SUBJECT: Docket No. 070-03098
Shaw AREVA MOX Services Response to the Request for
Additional Information Regarding Human Factors Engineering

REFERENCE: 1. Letter from Kevin Morrissey to Dealis Gwyn dated March 27,
2009 entitled "Request for Additional Information Regarding the
Review of the Human Factors Engineering Information in the
License Application and Integrated Safety Analysis Summary for
the Mixed Oxide Fuel Fabrication Facility"

Response to Request for Additional Information Regarding the Review of Human Factors Engineering

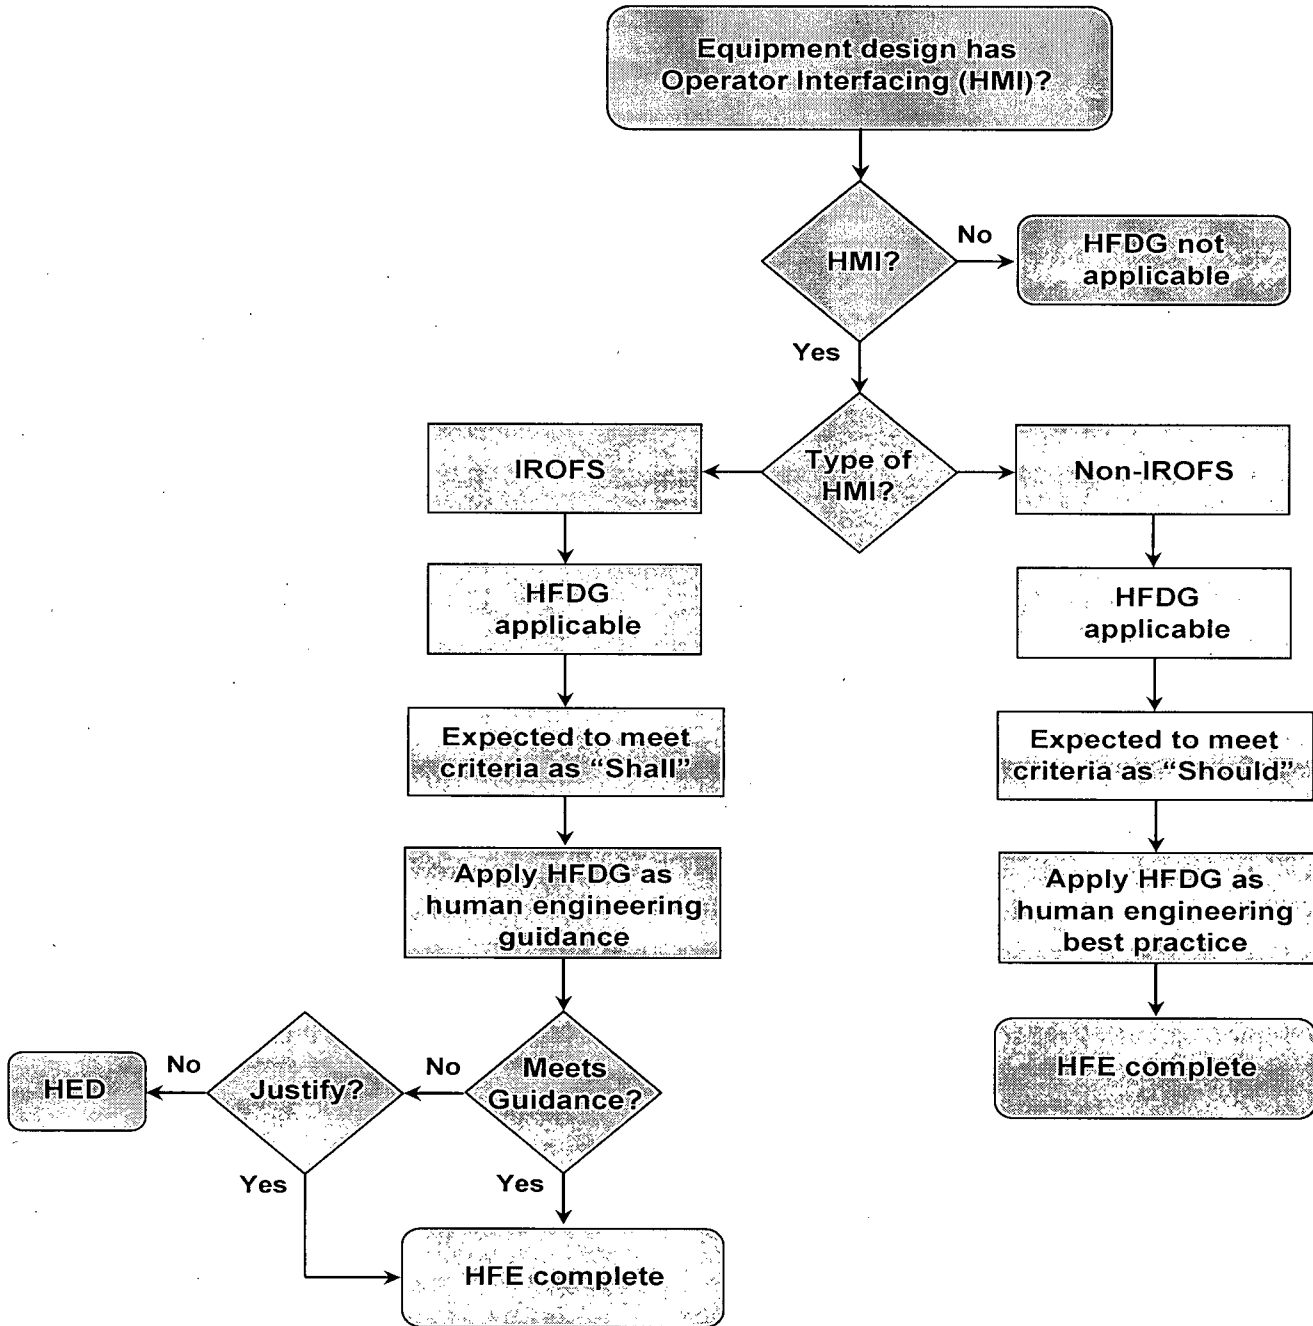
HFE – 11 HSI Design Style Guide

HSI design is addressed in LA Section 12.6 and in HEIP Section 8.5. These sections indicate that prior to detailed design work, the MFFF HFE team will compose and provide an appropriate "guidelines document" or "style guide" limited to suitability for the evaluation of IROFS equipment that have human interfacing. Does this mean the style guide will only be used for evaluation? Why is the scope limited to IROFS equipment? If limited as such, might that create inconsistencies in design between IROFS and non-IROFS HSIs? What is the general content of the style guide and how will it be maintained? Will it contain procedures for its use?

Does this mean the style guide will only be used for evaluation?

Why is the scope limited to IROFS equipment?

No. It also will be used to guide the Human Machine Interface (HMI) design development. HFIP section 8.5 was clarified to remove "style guide limited to suitability," and insert "for design guidance and evaluation of IROFS equipment having human interfacing." Note: the HFE Team decided to provide a Human Factors Design Guide (HFDG), not a "style guide."

The MFFF project has committed to applying HFE principles to HSI associated with operator actions interfacing with IROFS. HFE principles will be applied to Defense-in-Depth items as defined in the HEPP and HFIP. There is no commitment to apply the HFE program to other non-IROFS HSIs. The current design of non-IROFS equipment and systems has been on-going utilizing the reference plant design concepts and the HFDG will not be utilized as retroactive design review. The HFDG is now issued and training on the use will be performed in the near future. The HFDG will be utilized as "good engineering practices" where appropriate for non-IROFS equipment and systems.

The following flow chart figure is explained in the HFDG and training teaches the attendees how the flow chart works. Our utility document, HFDG, provides a MFFF oriented easy-to-use source of human factors guidance. The MFFF HFDG presents human factors design guidance that **shall** apply to IROFS and **should** apply to non-IROFS MFFF facilities, systems, processes, and equipment managed, operated, and

maintained by the MFFF operators. If IROFS having HMI are present, the HFDG is applied as a "shall" document; this agrees with the figure. If non-IROFS having HMI are present the HFDG is applied as a "should" document. The reason for this is to keep consistency in the HFE design across the plant and to further reduce human error. The non-IROFS "should," applies to engineering changes or modification affecting HMI, and for new equipment. The control rooms are included in the non-IROFS side of the chart, except for the few equipment items that are IROFS in the control room, for example the annunciator panels, or the safety panels that "shall" meet the HFDGs. The figure is viewed as accommodating the D-in-D, the control rooms and the other non-IROFS modified or new equipment and thus does not need changing.

MOX HFE Team is providing a human factors engineering design guideline (HFDG), not a style guide, and it is consistent with NUREG 0700 Rev 2. This utility document will provide a MFFF oriented easy-to-use resource for human factors guidance. The guide covers a broad range of human factors topics that pertain to automation, maintenance, human-machine interface, workplace design, documentation, system security, safety, the environment, and anthropometry. The HFDG will be subject to updates and revision as the need arises. Because the human factors design guide is an approved project document it is revised, reviewed, approved and maintained in accordance with approved project records management procedures. The flowchart below shows the procedure for using the HFDG, and is included in the HFDG:
